Strada - Additional Stream Flow Monitoring Stations Required

Fig H.27

Strada Proposed Quarry
DRAFT

Table H.4

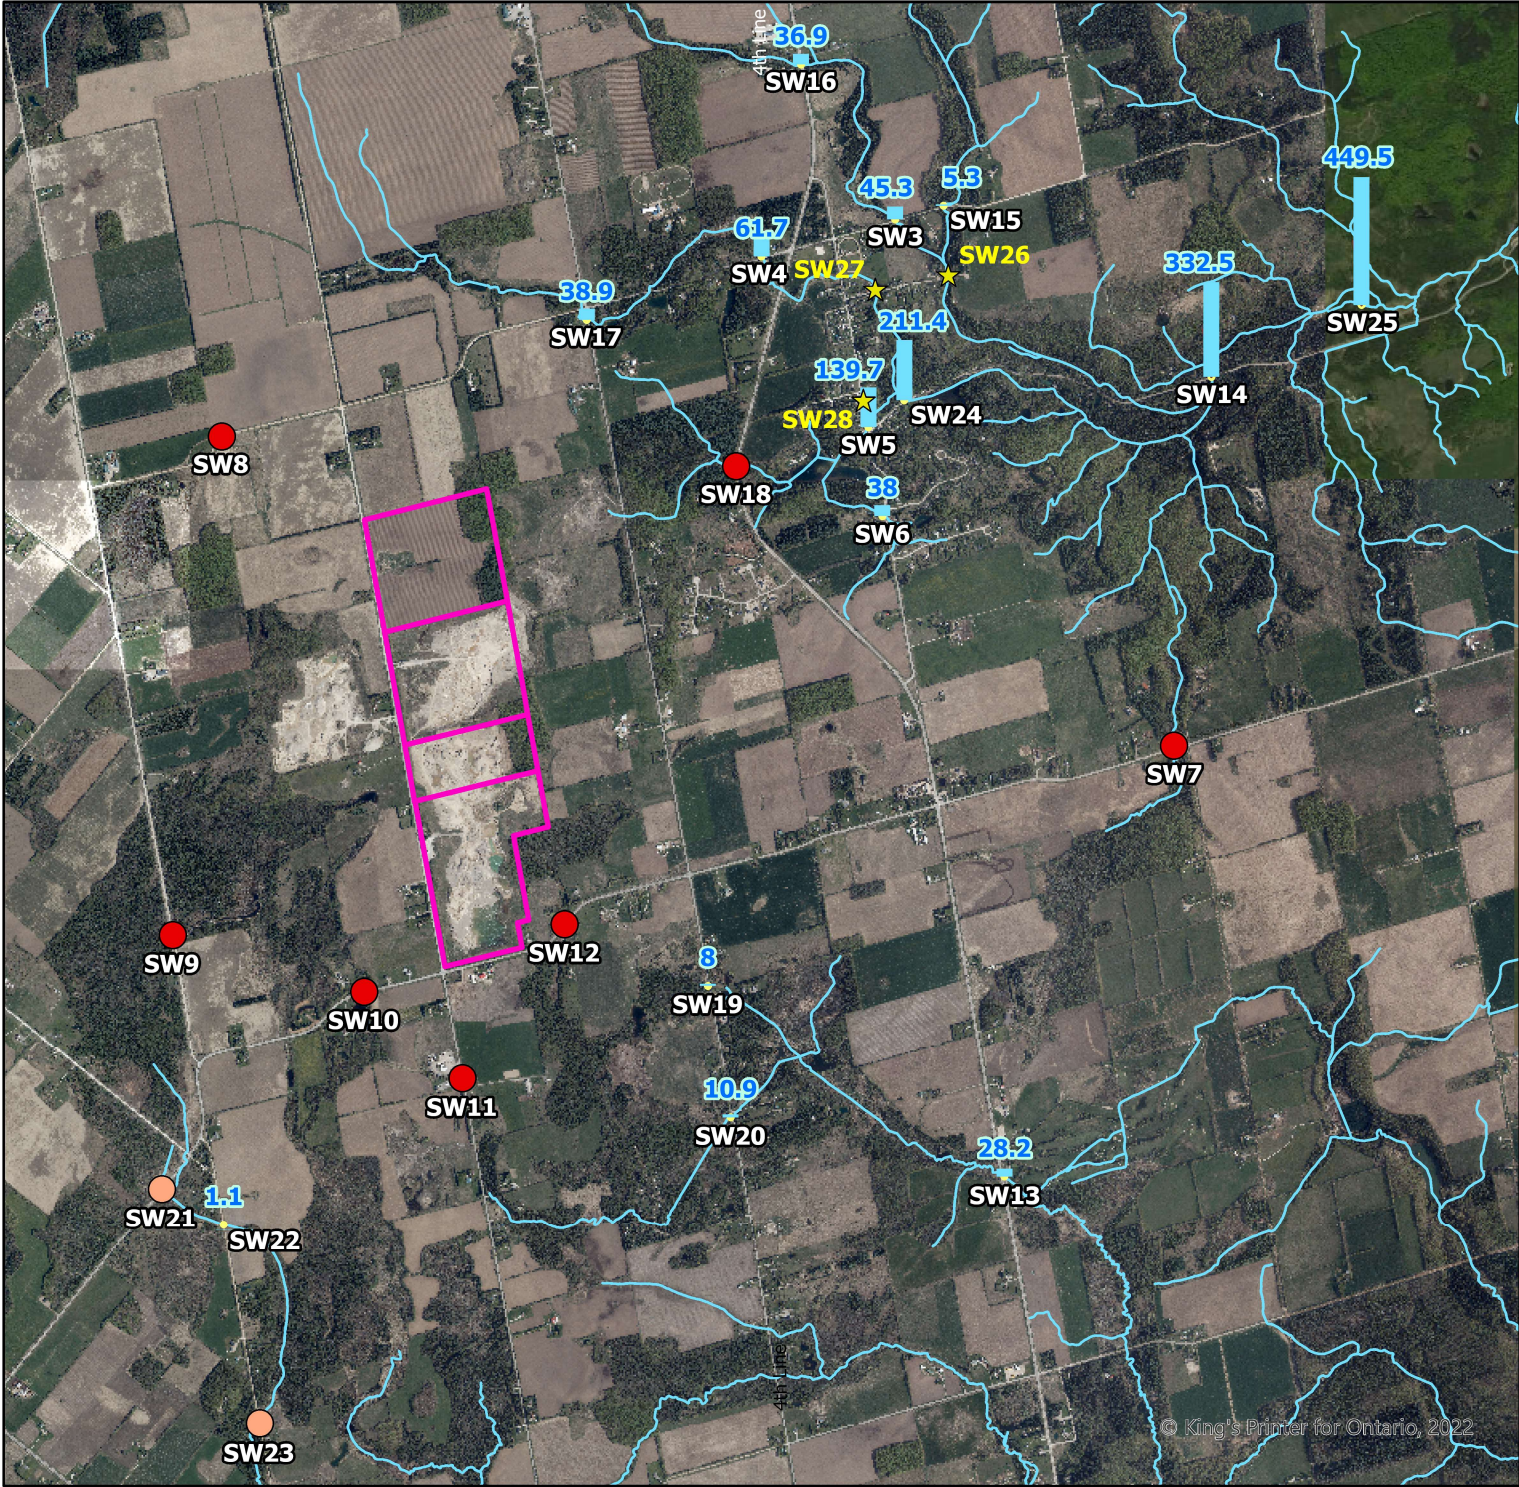
Additional Monitor Station Required
